GD23 Draft Determination Response

MAY 2022

SGN Natural Gas (SGN NG) welcome the opportunity to engage with the Utility Regulator (UR) on the proposed decision set out within the Draft Determination (DD). As the most recently constructed network in the UK, SGN NG is uniquely placed to be the first hydrogen ready network to transition our customers from natural gas to hydrogen and biogas and to play a leading role in delivering the NI Energy Strategy utilising local resources and local production to deliver this change.

Figure 2.2: Relationship between marketing expenditure, enquiries and connections

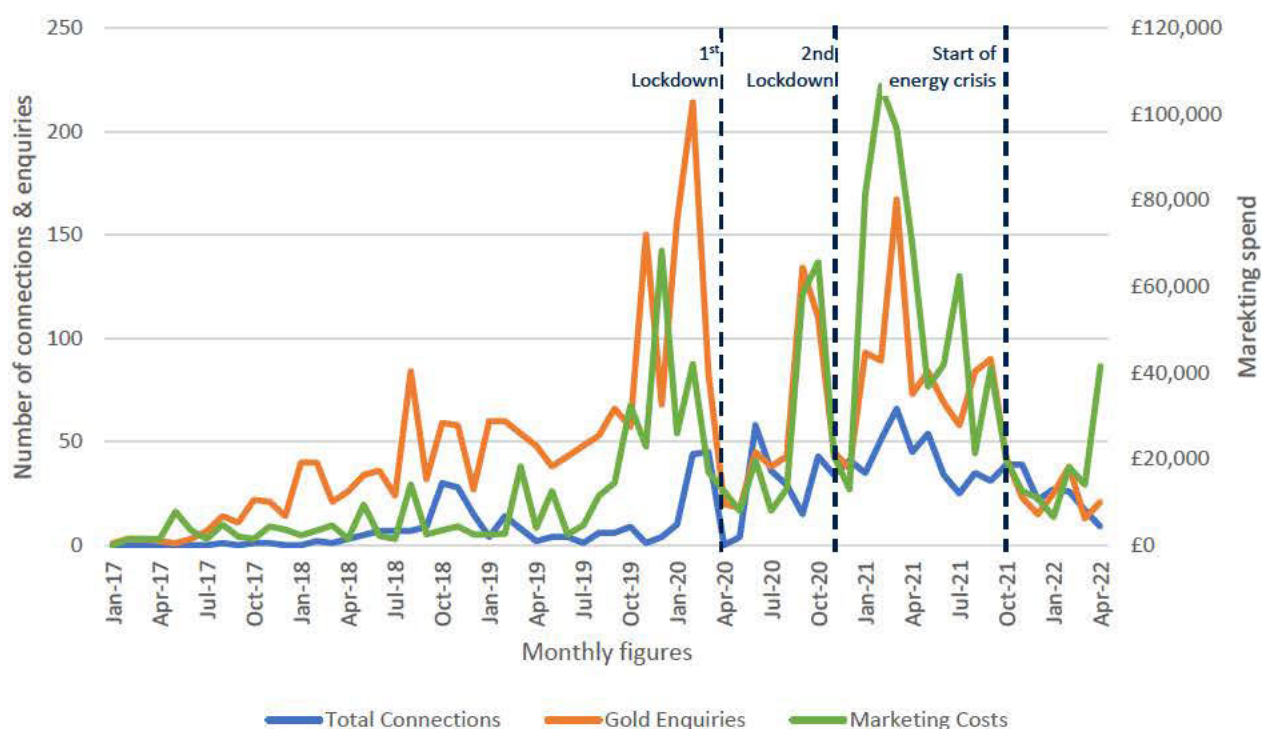
Figure 2.2 above, shows a strong correlation between marketing expenditure the number of enquiries generated, and the number of actual connections realised. Through the year the marketing budget changes

Replacing this with a cost to serve of £400/OO connection and a marketing budget of £125k/year as proposed in the 'cost to serve' model put forward in the DD would be catastrophic in terms of the impact on marketing expenditure and the resulting impact on enquiries and connections. In particular, but not exclusively, SGN NG believes it is unreasonable to review Figure 2.2 and other similar data sets and conclude that a reduction in marketing budget to less than 20% of previous levels will result in anything other than a collapse in the realisation of connection opportunities.

Figure 4.1: Relationship between marketing expenditure and high-quality enquiries

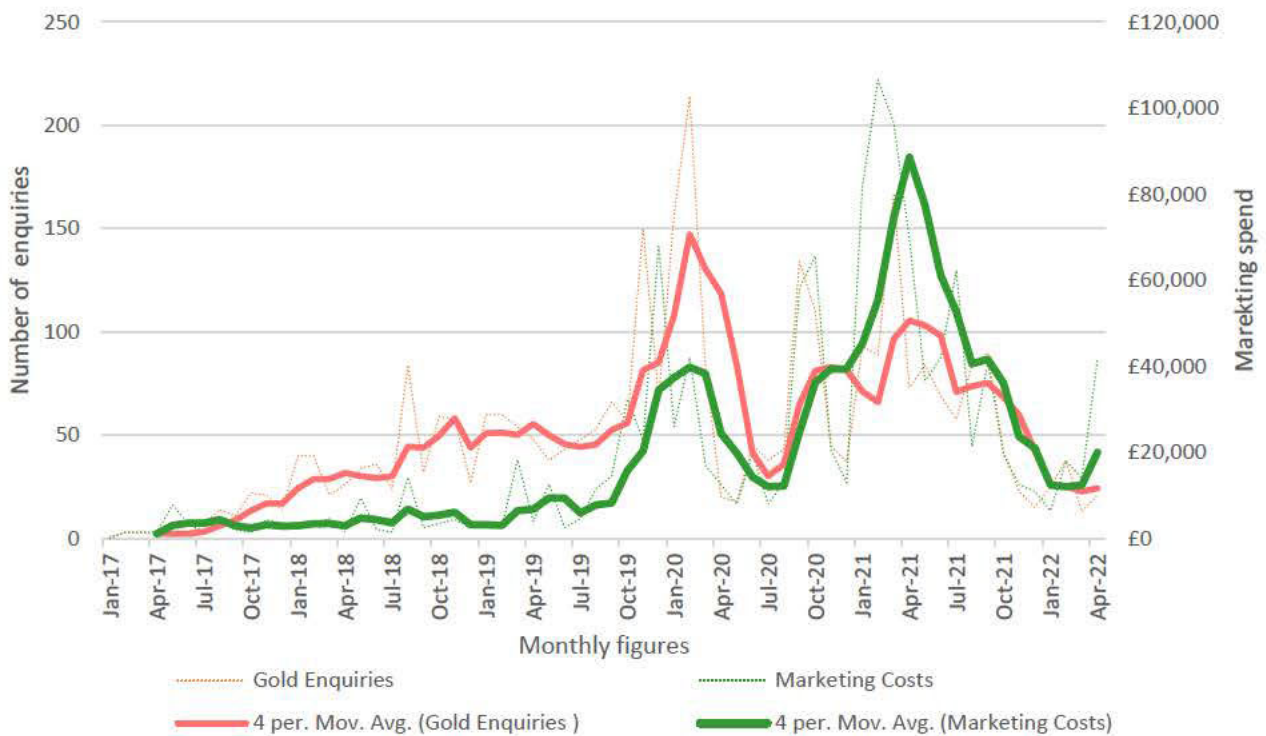
In Figure 4.1 below we traced the relationship between marketing expenditure during GD17 and connection enquiries, while Figure 4.2 shows the relationship between connection enquiries and number of connections. Figure 4.1 shows a strong correlation between the four-month moving average for marketing expenditure and enquiries. Data was assessed up to Dec 2020³⁶ as part of our submission and on average over this four-year period, each high-quality enquiry ‘cost’ £258/OO connection. The period to December 2020 also gives an average ratio of 0.240 connections per high-quality enquiry.

Figure 4.2: Relationship between enquiries and the number of connections

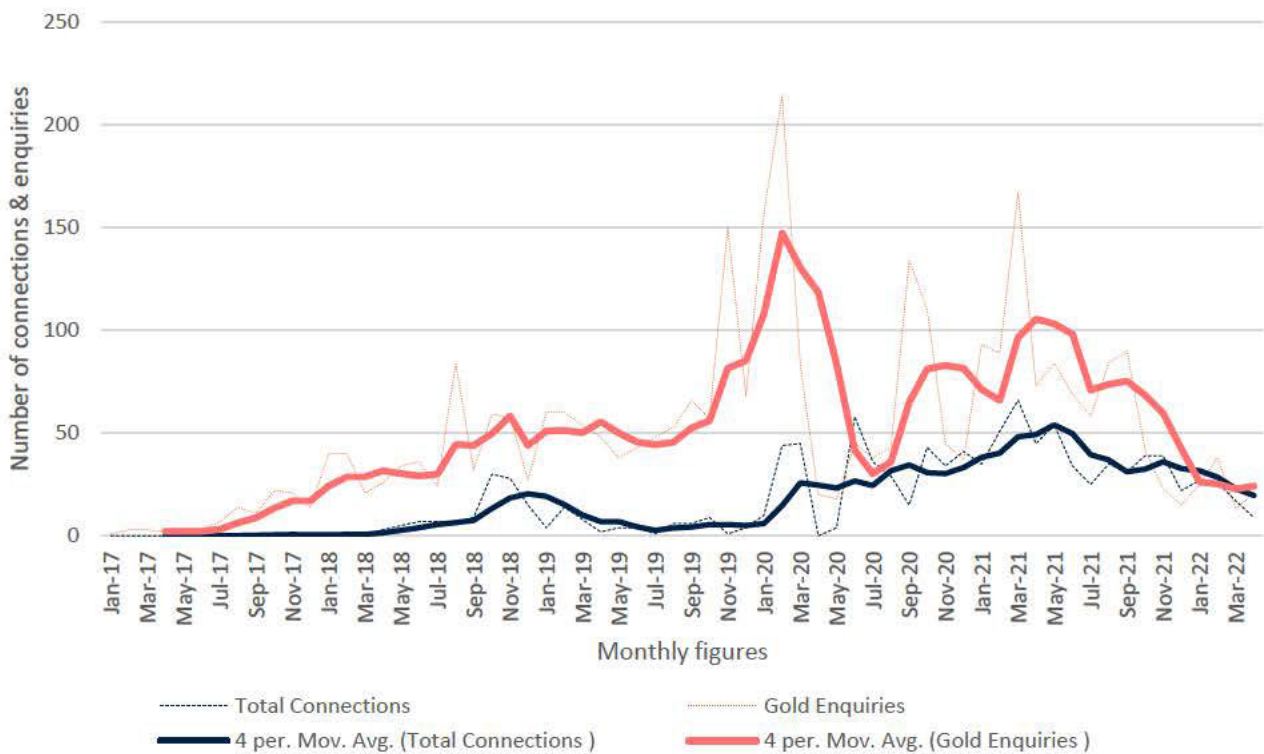
For every enquiry we identified in GD17 we were able to realise 0.24 connections and, on this basis, we can determine that the average annual connection rate for OO customers will fall from 136/year in GD17 to 90/year in GD23, rather than increasing to 622/year as we set out in our GD23 business plan.

Figure 4.5: Relationship between I&C incentives values and number of connections

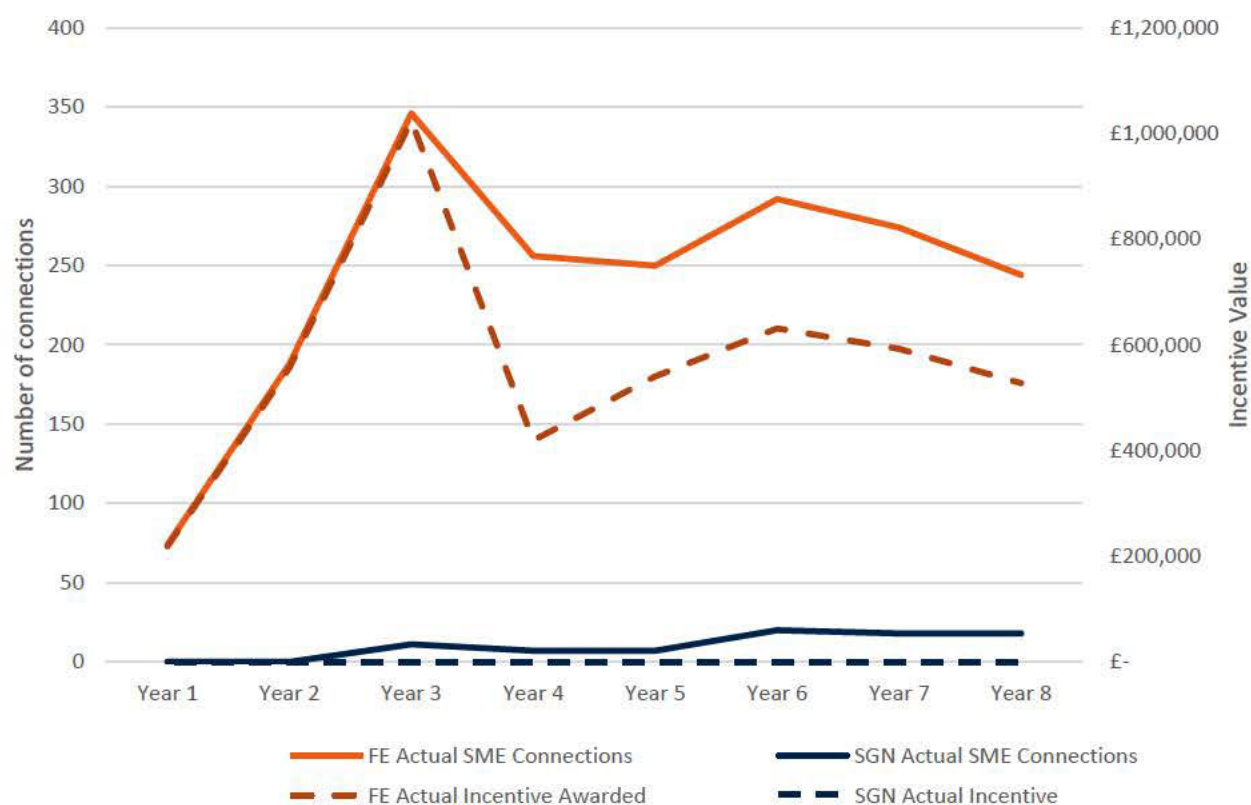
The relationship between the value of an incentive and the number of connections is clearly demonstrated in Figure 4.5 below which illustrates the correlation between incentive value and number of connections for FeDL during their first and second price control periods. This compares to the experience of SGN NG which did not have allowances for a connection incentive to support small and medium I&C customers and is shown on the same graph for comparison.

As a result, we have clear evidence from GD17 that without an I&C connections incentive there is no reason to expect that the actual connections will vary significantly from the average 18 connections per year forecast in the last years of GD17. Based on the DD proposal we anticipate the connection of an average of 22 small and medium I&C customers during the GD23 period which is significantly less than the 9238 connections per year assumed by the UR in the DD.
